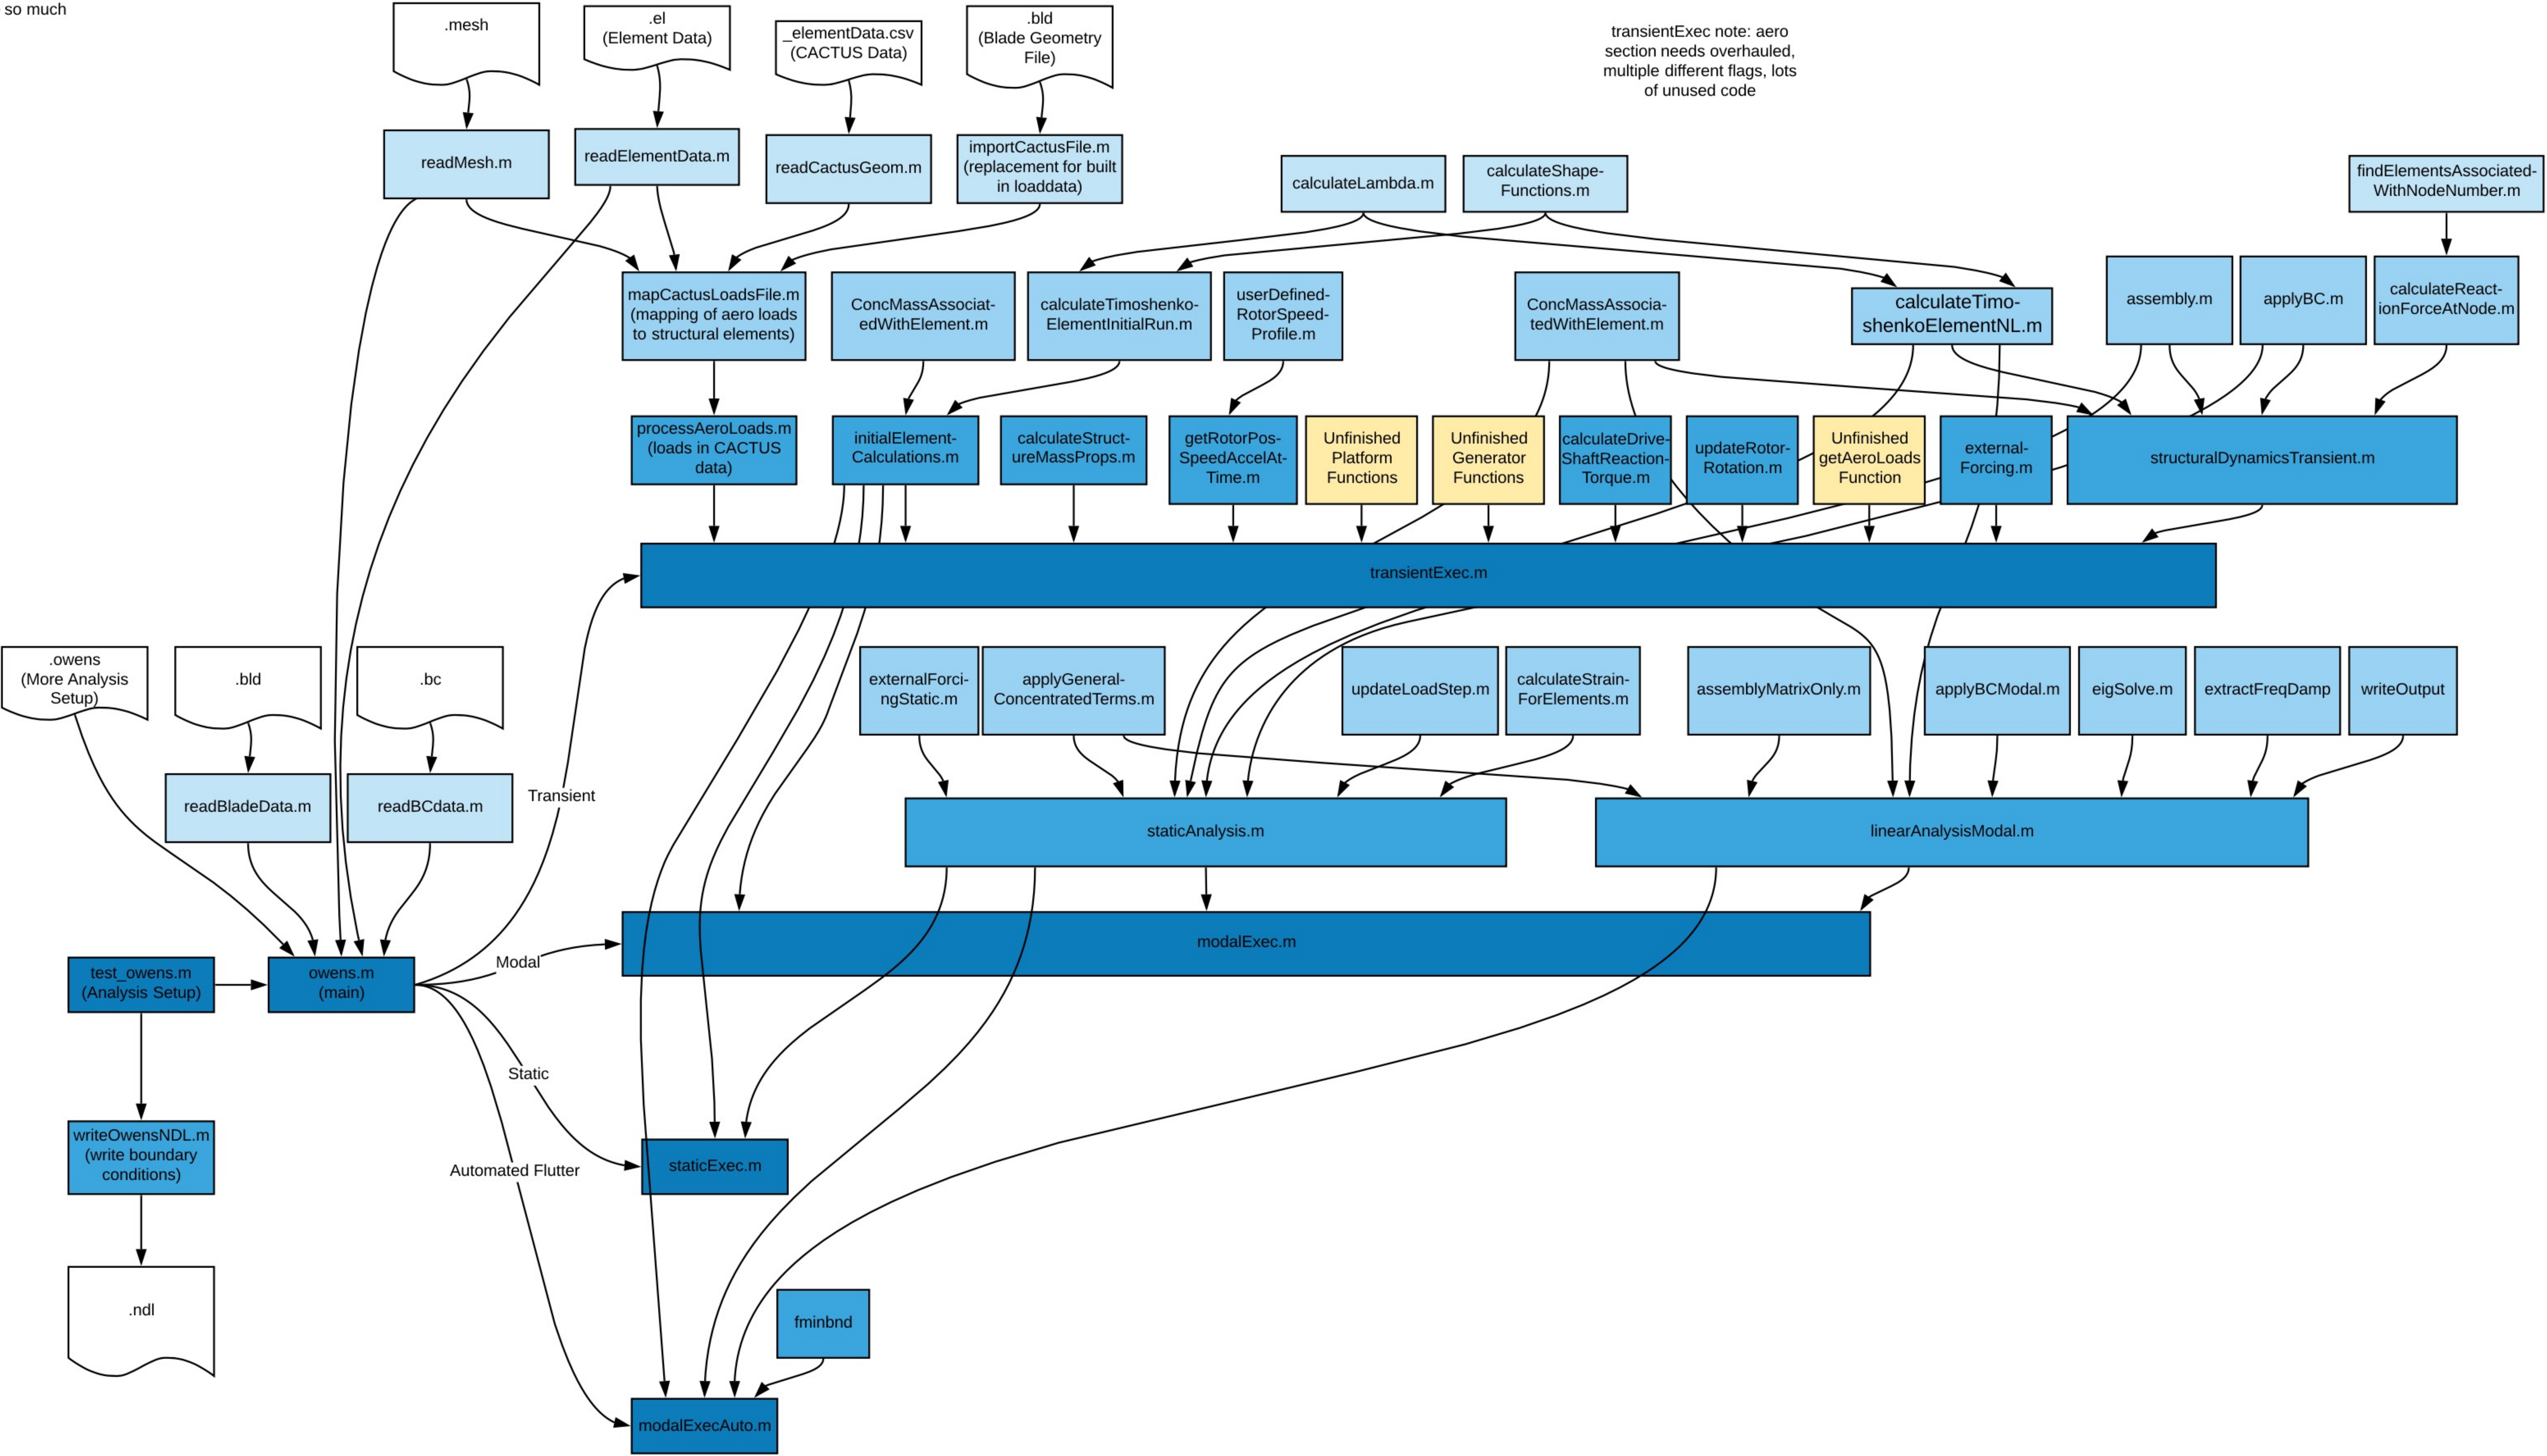
owens.m notes:
-The minor functions with just a few lines of code and only called once should be incorporated into owens.m and not as separate files
- Lots of parameters that should be pulled into the main analysis setup file (and their associated read-in functions removed)
- The vararg input needs to be made consistent and simplified.
- Comments need to be restructured so that it is clear which section/analysis is being conducted
- Structure should be updated to be concise, not repeating code so much

importCactusFile.m notes:
Should probably rename since it is moreso just a replacement for loaddata

transientExec note: aero section needs overhauled, multiple different flags, lots of unused code
